**Addendum #1**  
**2020 Roadway Improvement Project**  
**“Cambridge Drive Neighborhood”**  
**Bid No. 20-15**  
**Town of East Hartford**

**February 28, 2020**

The following summarizes the revisions to the Bid Documents included in Addendum #1 for the 2020 Roadway Improvement Project (Bid No. 20-15).

JEFFERSON LANE

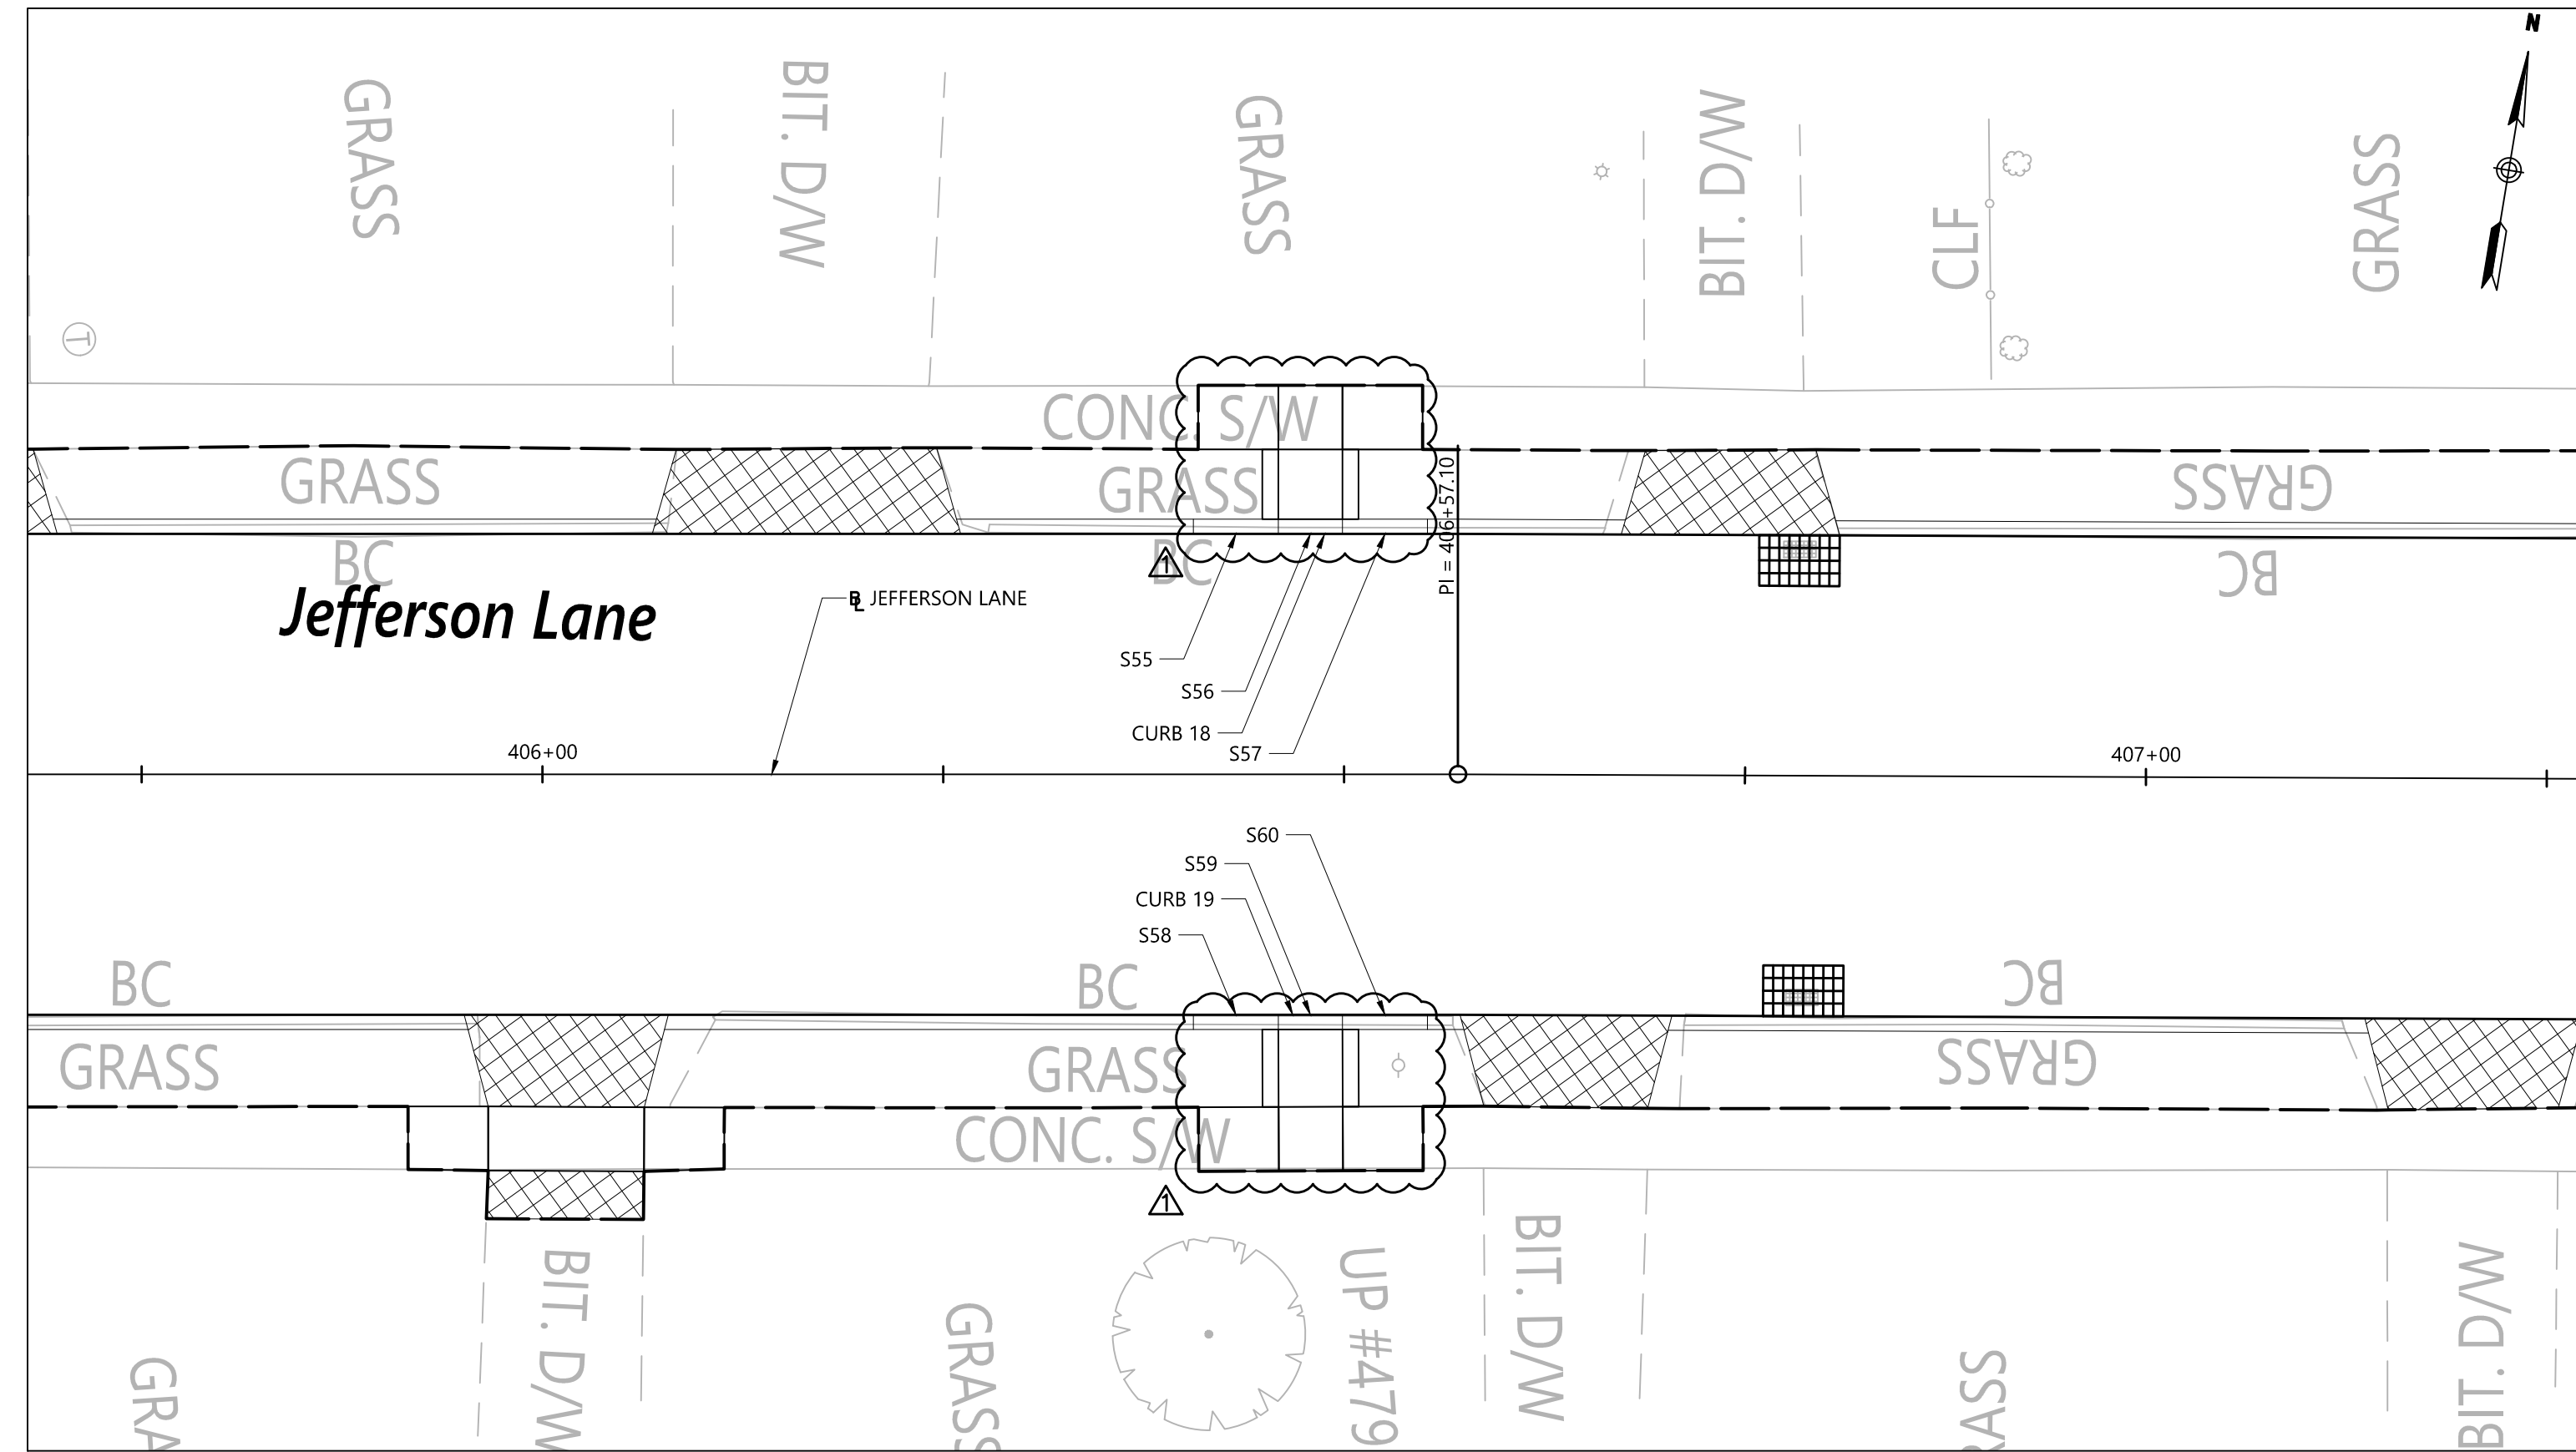
- Replace plan sheet 070 of 294 to reflect revisions to sidewalk ramp layout.

REV.	DATE	DESCRIPTION	REVISIONS	SHEET NO.
02/27/20	REVISED RAMP LAYOUT			070

PROJECT NO.: 42413.00  
DRAWING NO.: TIE-05  
SHEET NO.: 072 OF 294

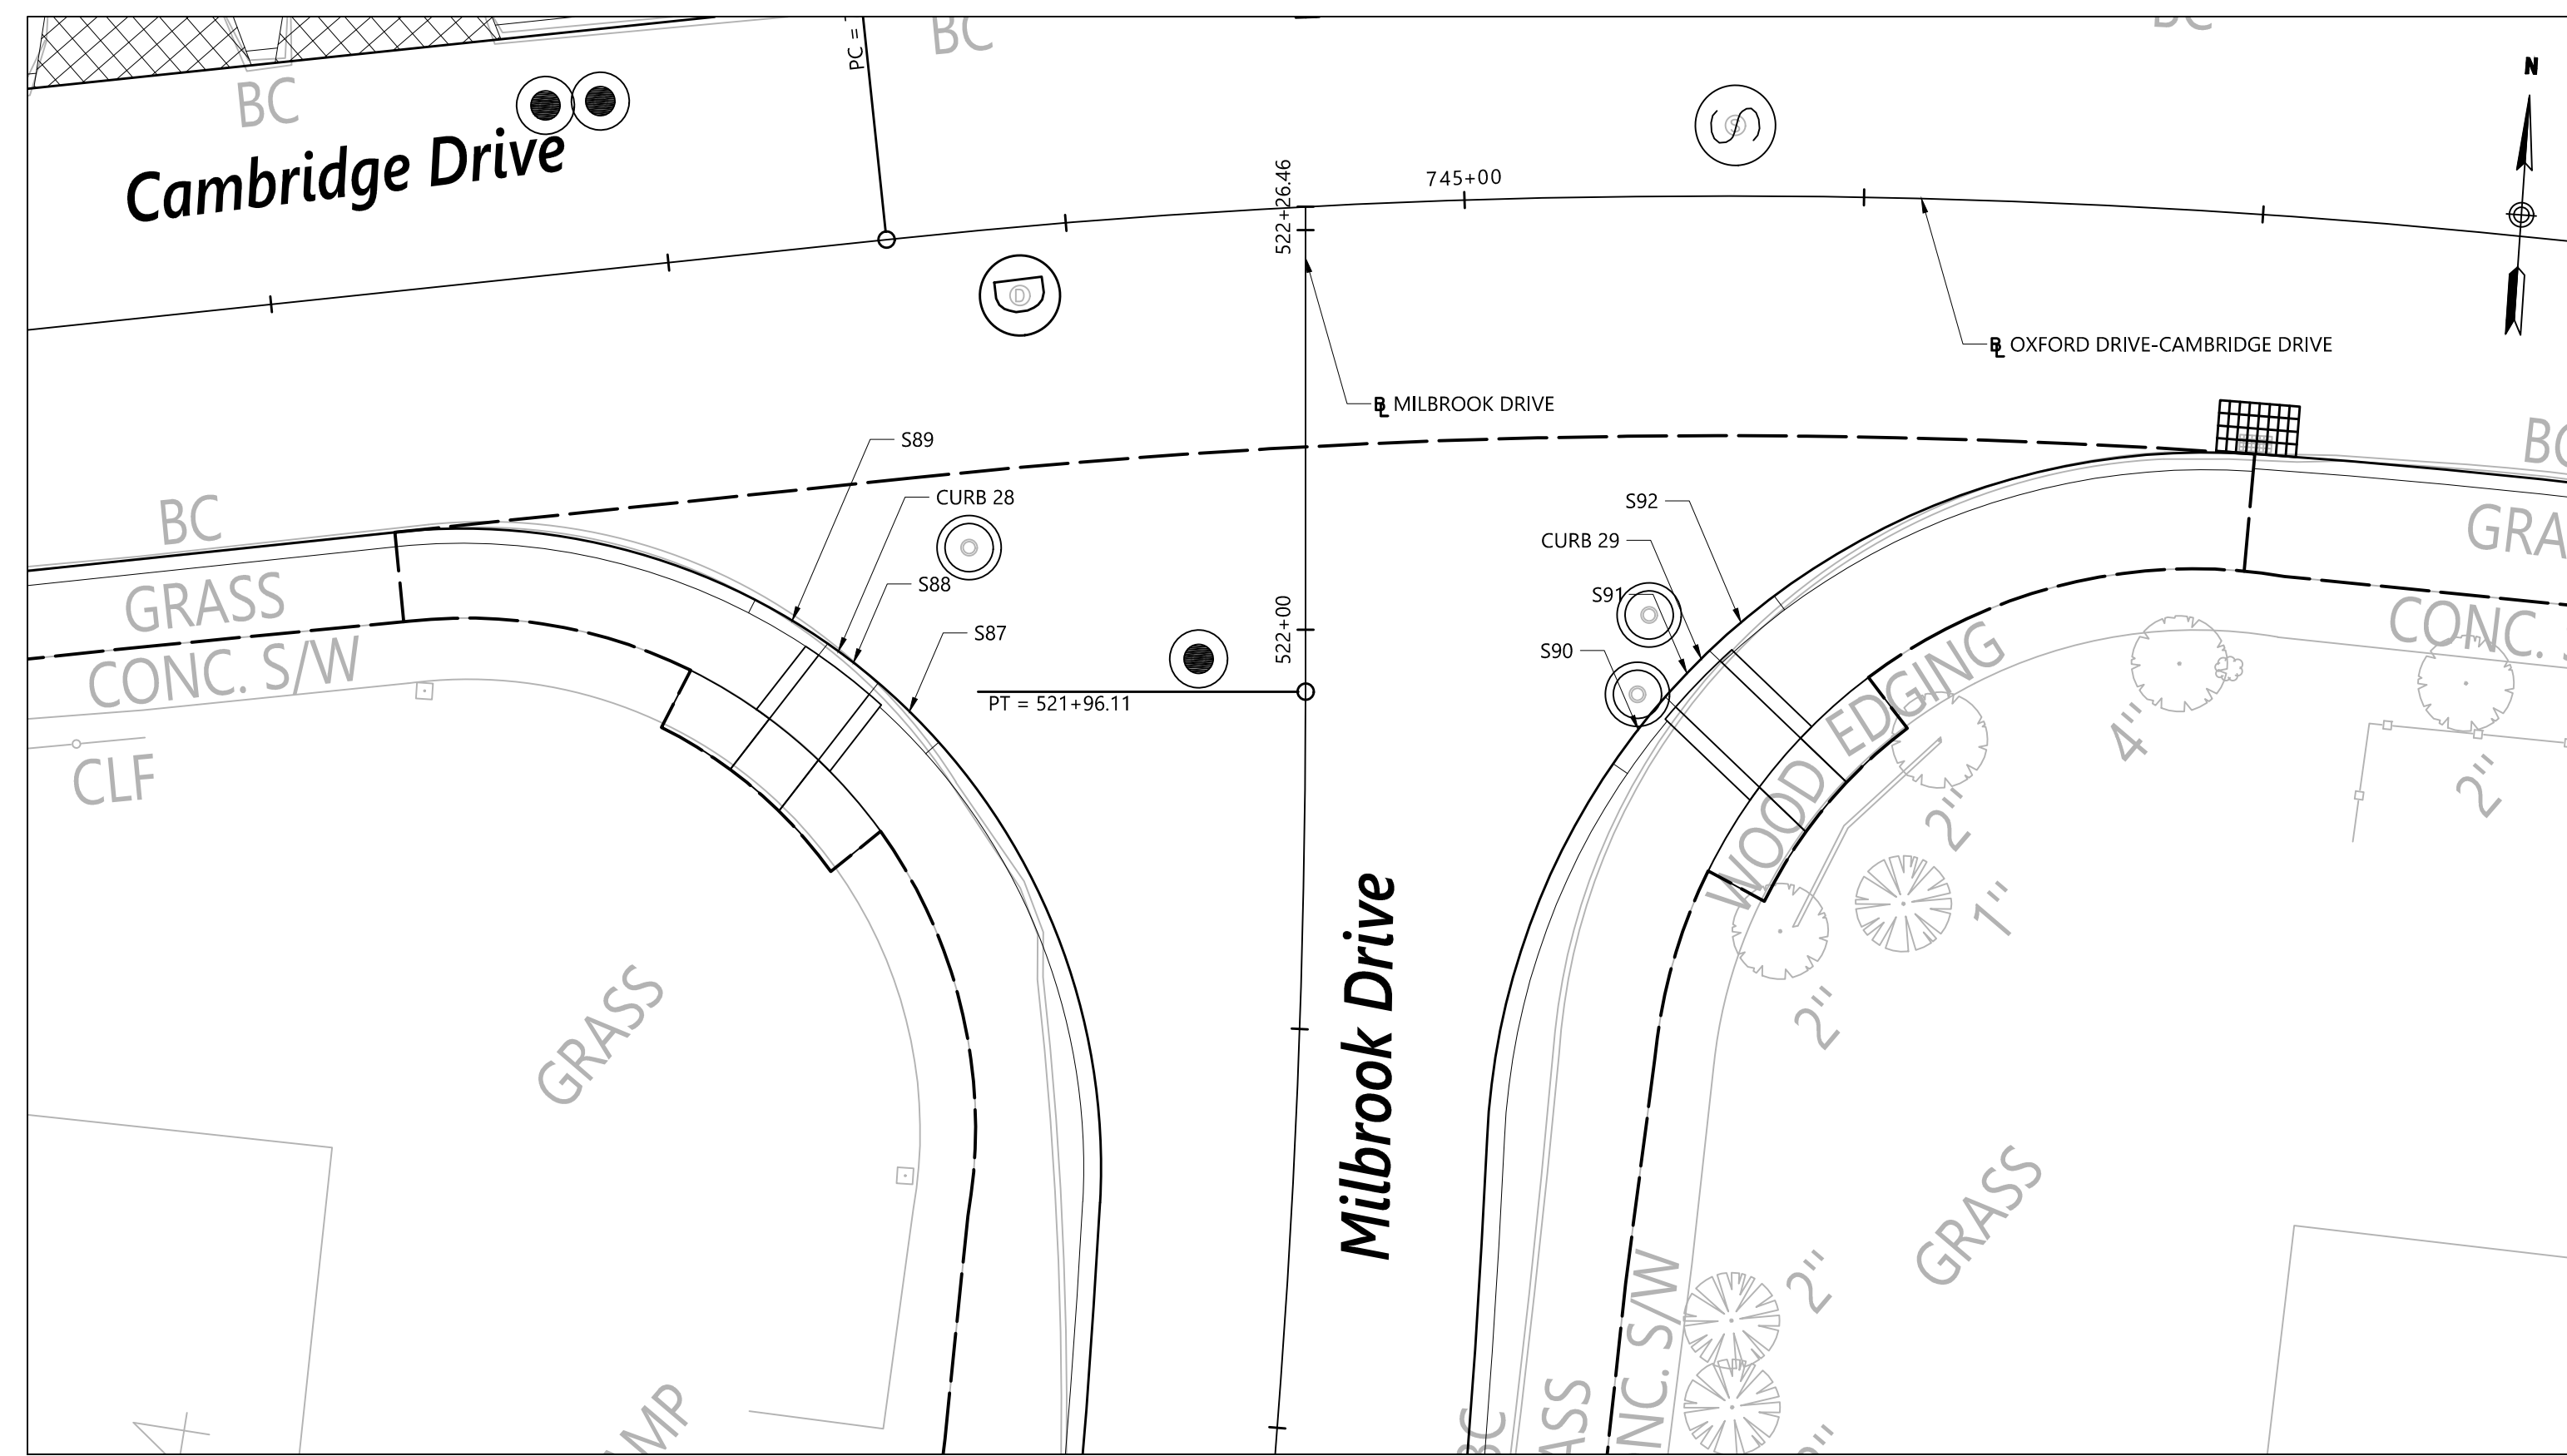
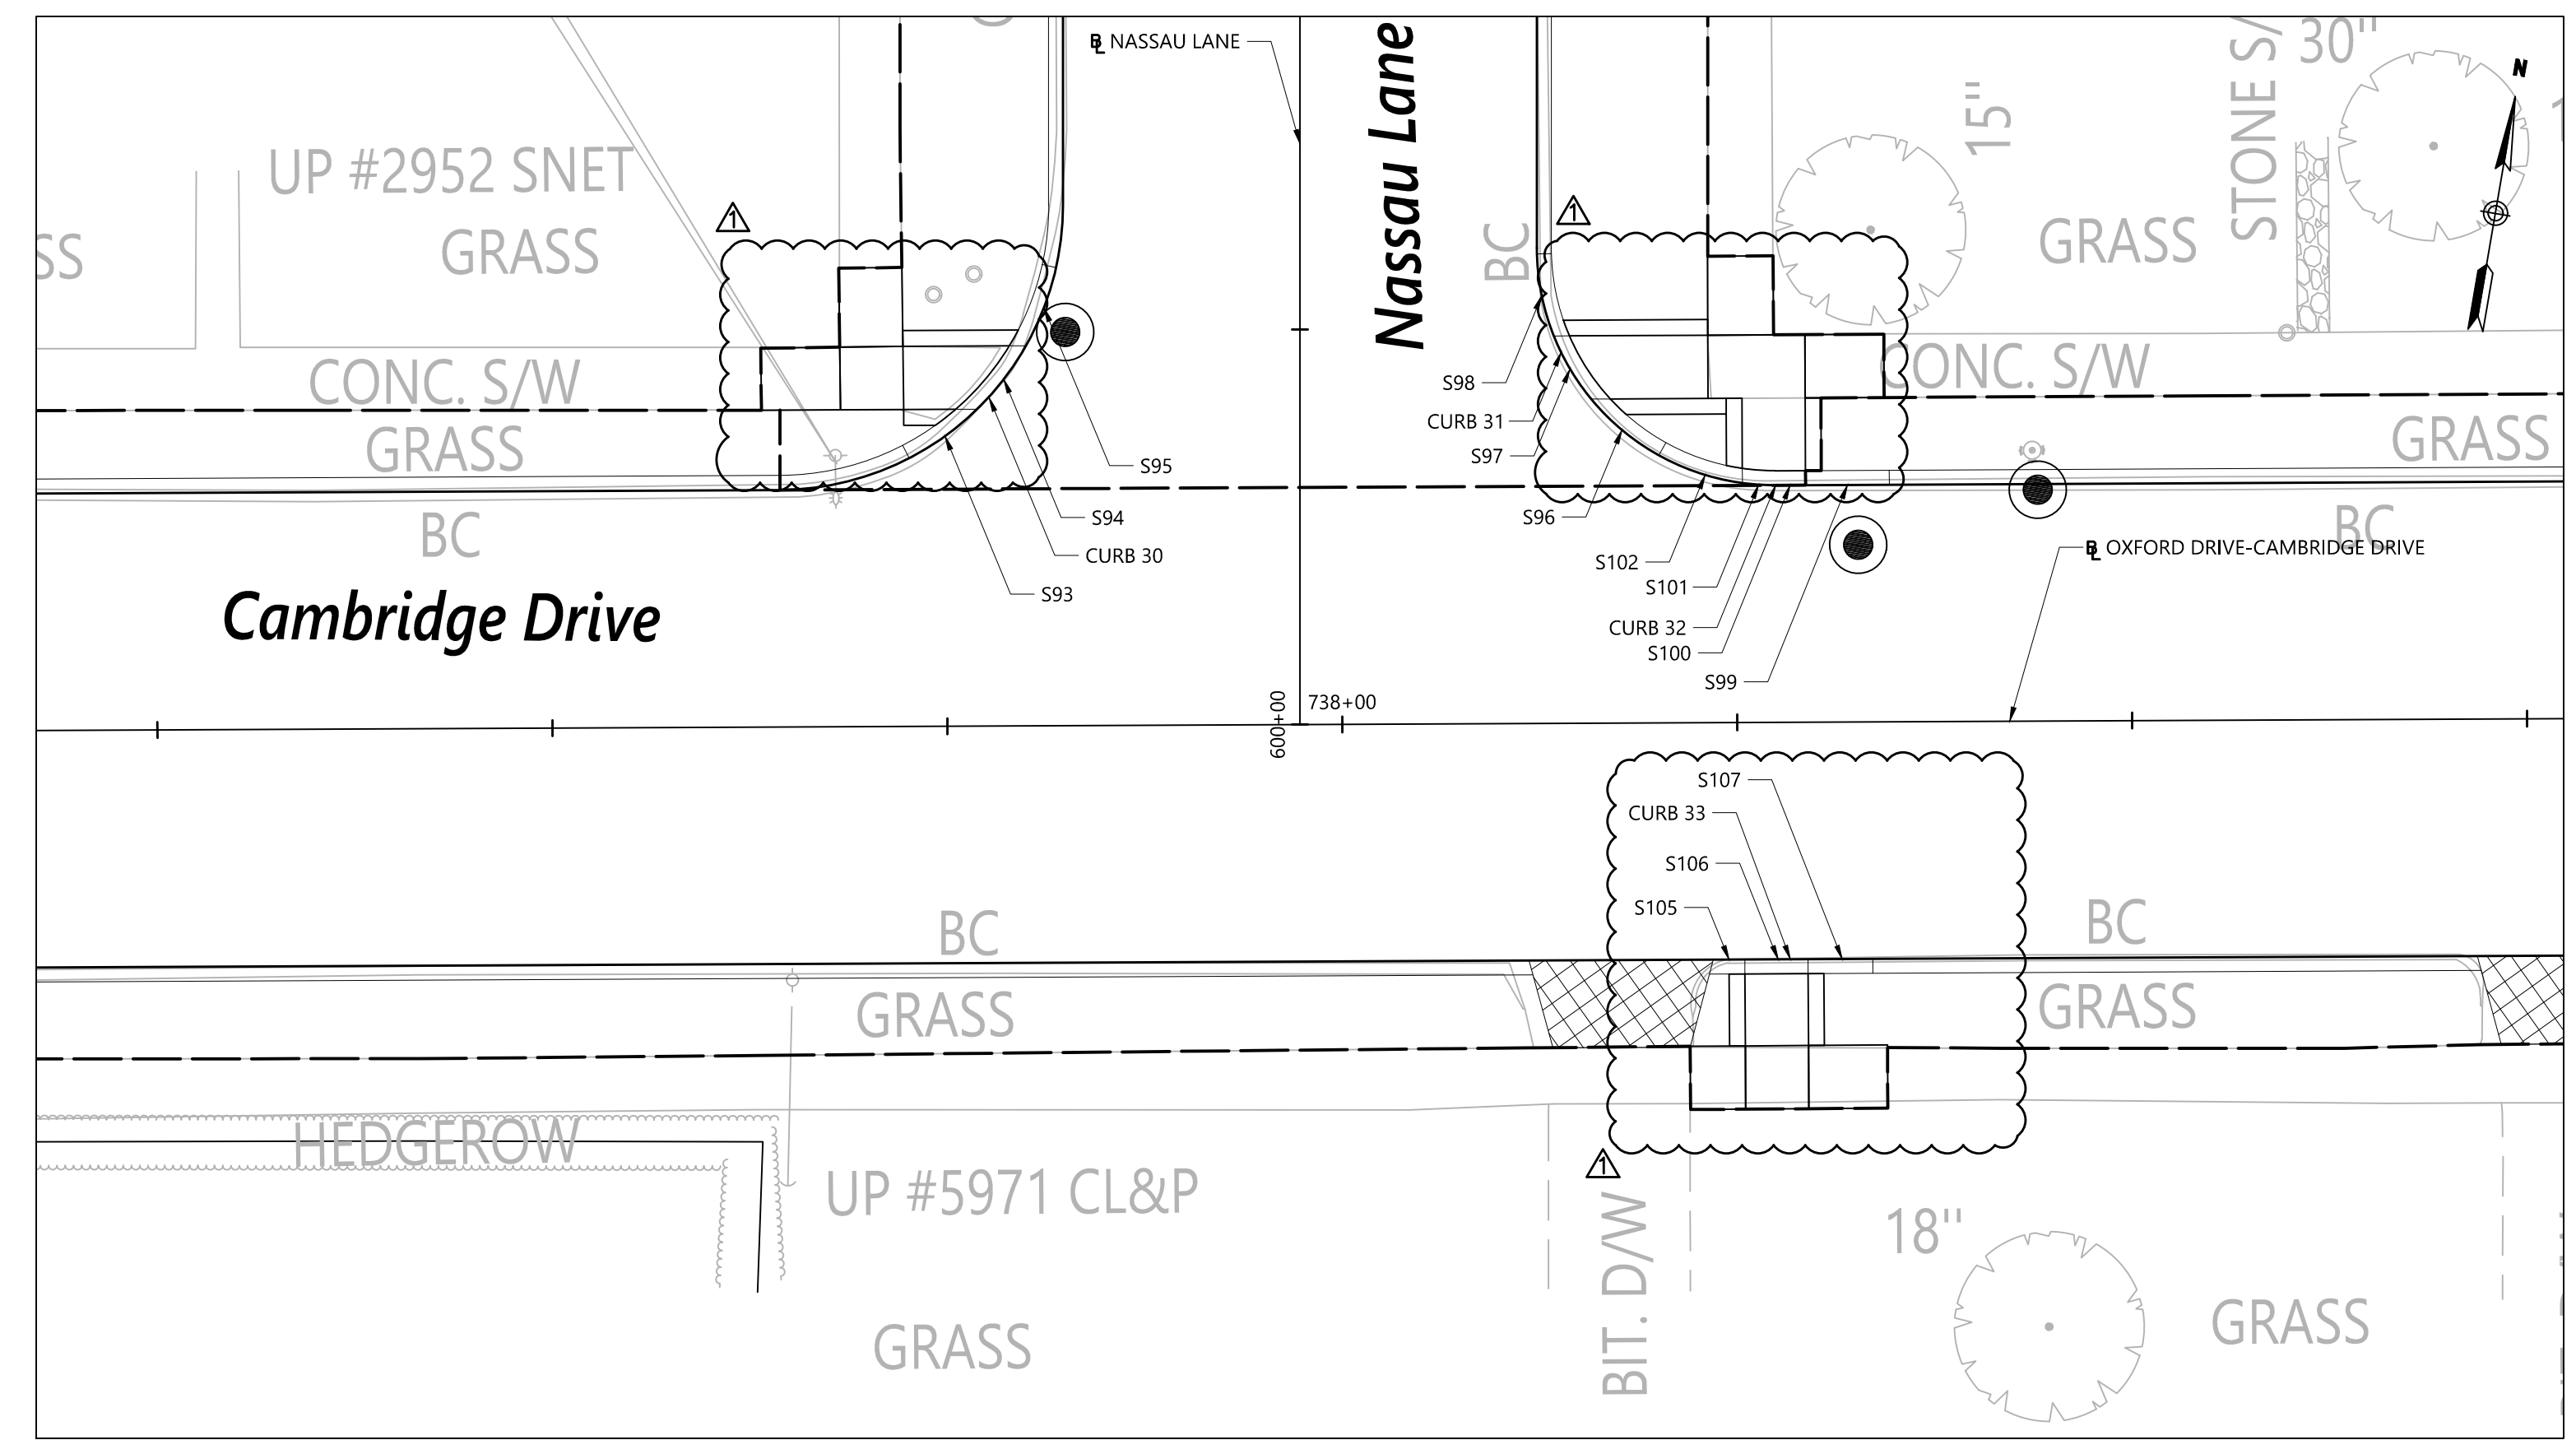
- Replace plan sheet 072 of 294 to reflect revisions to sidewalk ramp layout, curb layout, granite curb table, and calloffs.

REV.	DATE	DESCRIPTION	SHEET NO.
02/27/20	REVISED RAMP AND CURB LAYOUT, CURB TABLE, AND CALLOFFS	072
